Memorandum to the City of Markham Committee of Adjustment

January 8, 2021

File: A/092/20
Address: 19 Thorny Brae Drive – Markham, ON (Thornhill)
Applicant: Elina Eidkham
Agent: MDI Development Inc.
Hearing Date: January 20, 2021

3 PROPOSED EAST ELEVATION
A-3 SCALE 3/16"=1'-0"

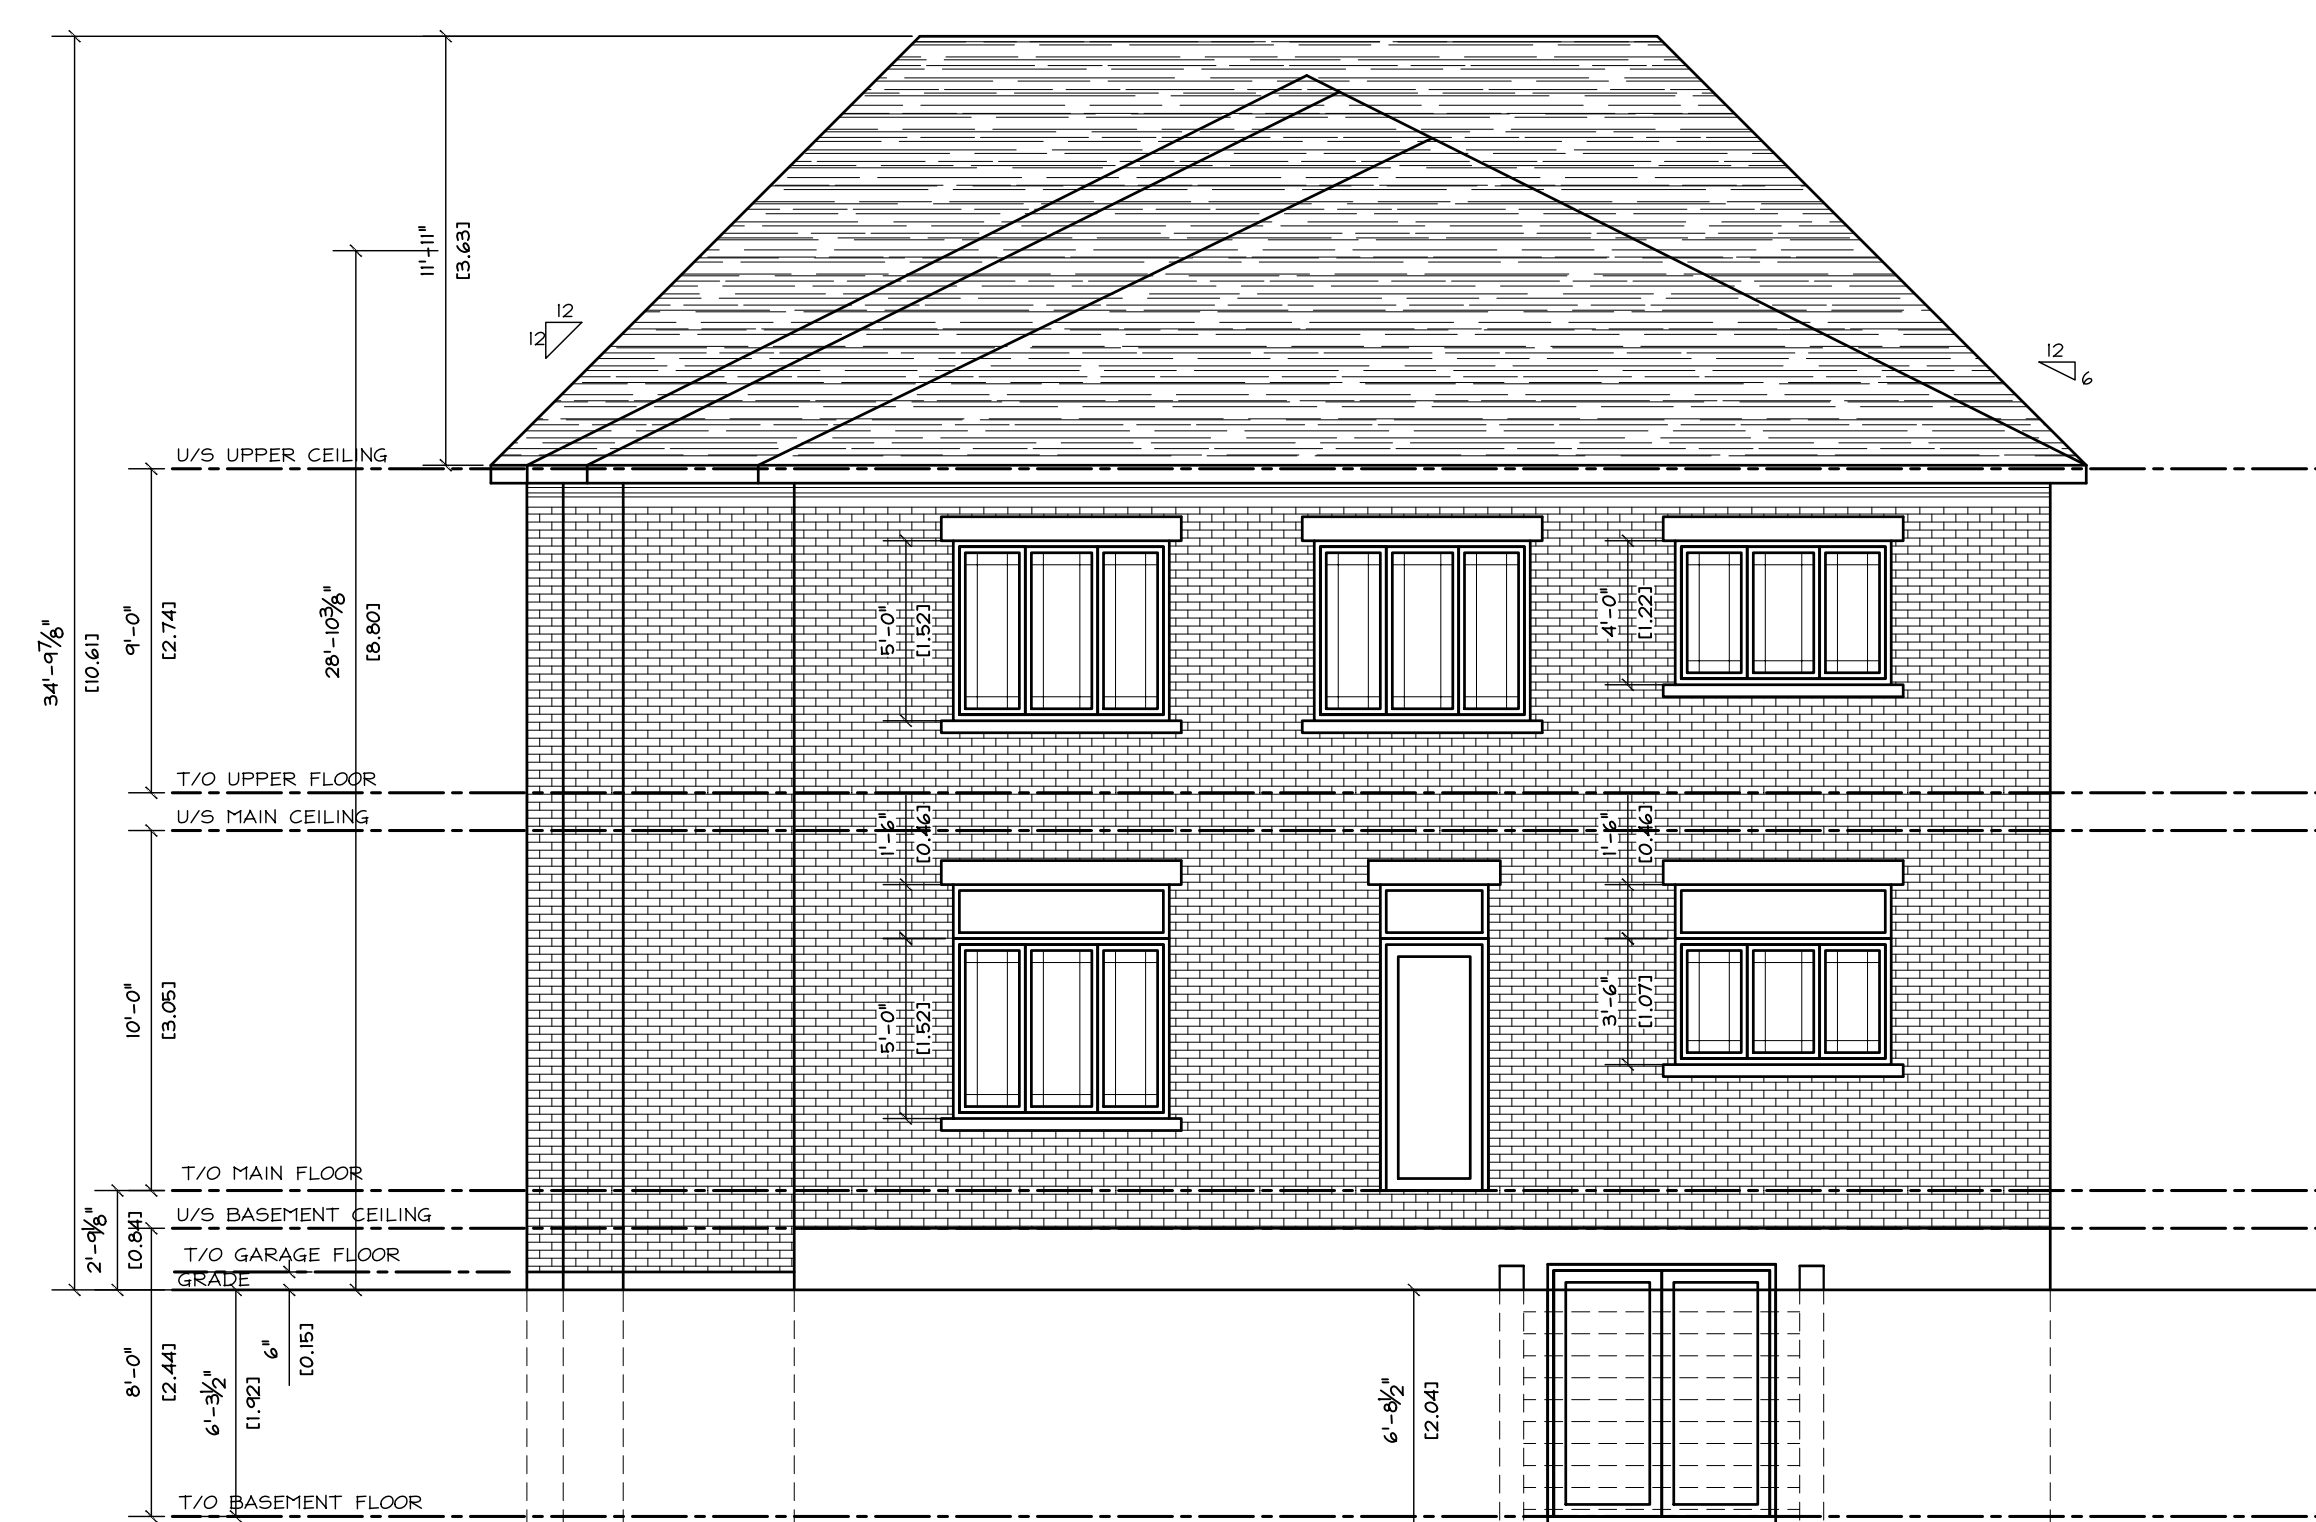
Increase in Maximum Building Height

The applicant is requesting a maximum building height of 28.87 ft (8.80 m), whereas the By-law permits a maximum building height of 25.0 ft (7.62 m). This is an increase of 3.87 ft (1.18 m).

The applicant initially proposed a height of 9.10 m (29.86 ft). New infill developments should have regard to the height and massing of established homes to ensure the overall character of the neighbourhood is maintained. In considering the scale of the existing built form within the surrounding area regulated by the By-law permissions in effect, staff had some concern with the initial variance request. The applicant has worked with staff to reduce the height of the proposed dwelling, and while the reduction is minimal, staff are of the opinion that the revised height is more to scale with other existing dwellings within the surrounding area built circa 1967.
